CITY OF CODY
PLANNING, ZONING AND ADJUSTMENT BOARD
TUESDAY, OCTOBER 23, 2012
CITY HALL COUNCIL CHAMBERS @ 12:00 NOON

MEETING DATE:	OCTOBER 23, 2012	TYPE OF ACTION NEEDED	
AGENDA ITEM:		P&Z BOARD APPROVAL:	X
SUBJECT:	SITE PLAN REVIEW: GEE PROFESSIONAL OFFICE BUILDING (702 PLATINUM AVENUE) FILE NO. SPR 2012-41	RECOMMENDATION TO COUNCIL:	
PREPARED BY:	TODD STOWELL, CITY PLANNER	DISCUSSION ONLY:

MEETING DATE:	OCTOBER 23, 2012	TYPE OF ACTION NEEDED	
AGENDA ITEM:		P&Z BOARD APPROVAL:	X
SUBJECT:	SITE PLAN REVIEW: WYOMING AUTHENTIC PRODUCTS (MEAT PROCESSING) SPR 2012-38	RECOMMENDATION TO COUNCIL:	
PREPARED BY:	TODD STOWELL, CITY PLANNER	DISCUSSION ONLY:

GREASE INTERCEPTOR AND SEWER SERVICE DETAIL
N.T.S.

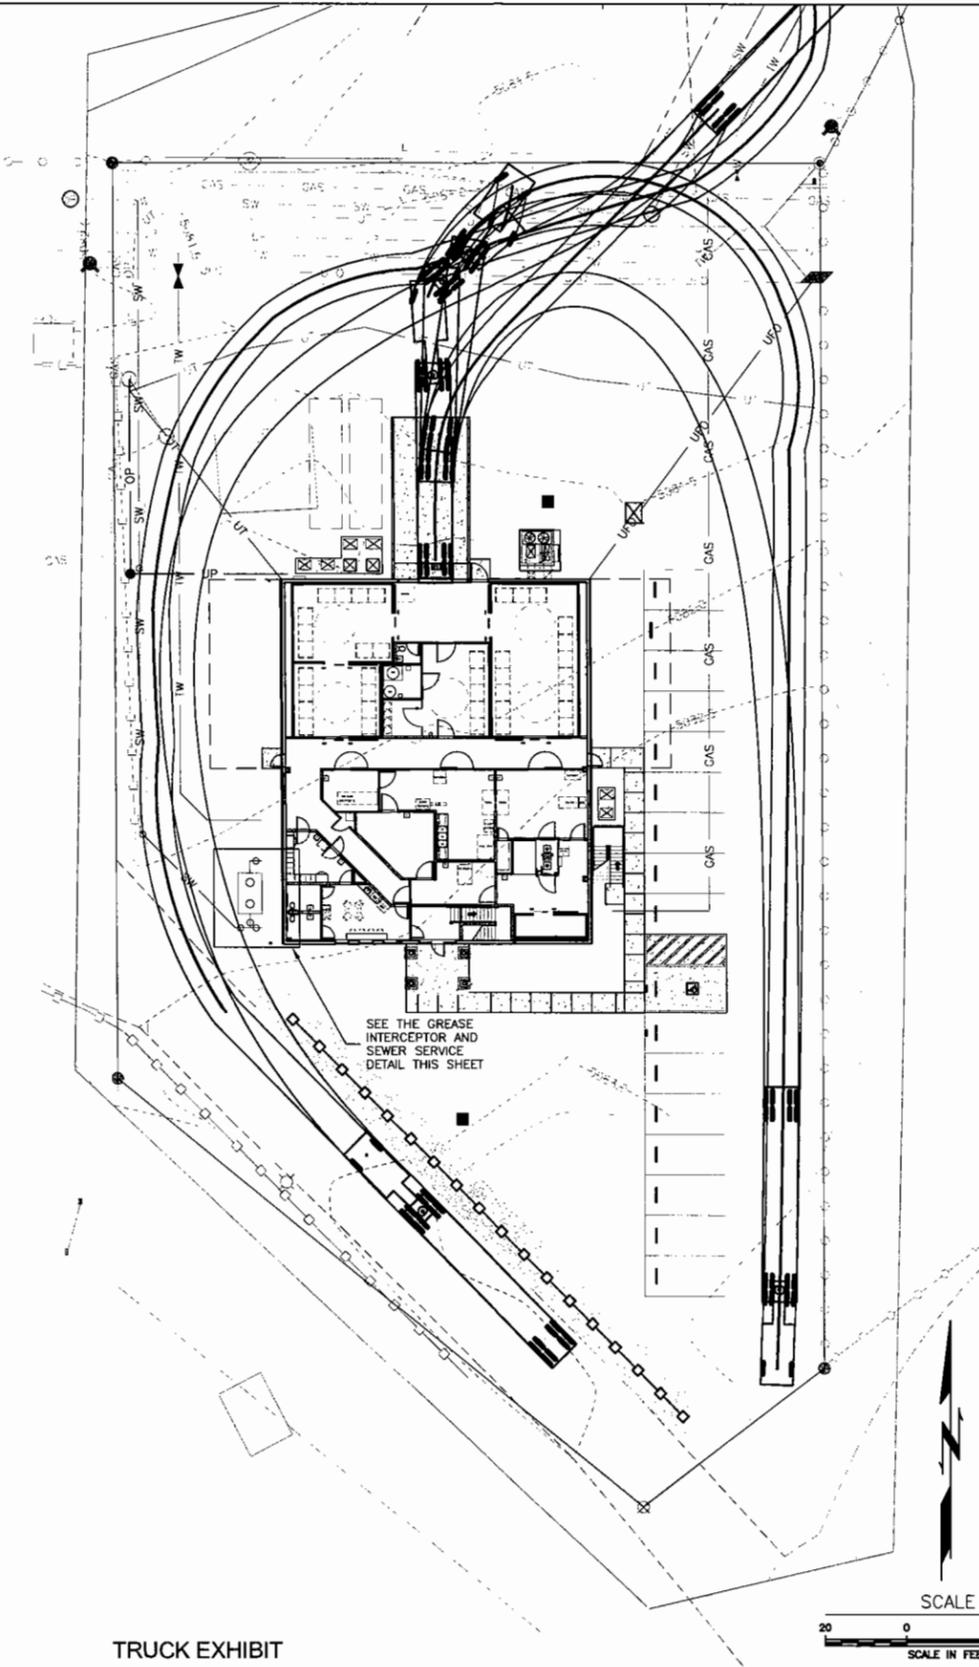
- ~~9. Identify the snow removal areas on the site plan and ensure that runoff from the melting snow piles is retained on the site.~~
- ~~10. Move the grease separator closer to the building to get it out of the driveway and place barriers to protect it from traffic.~~

Response: We have relocated the grease interceptor off of the path of travel. We have also included a traffic rated lid.
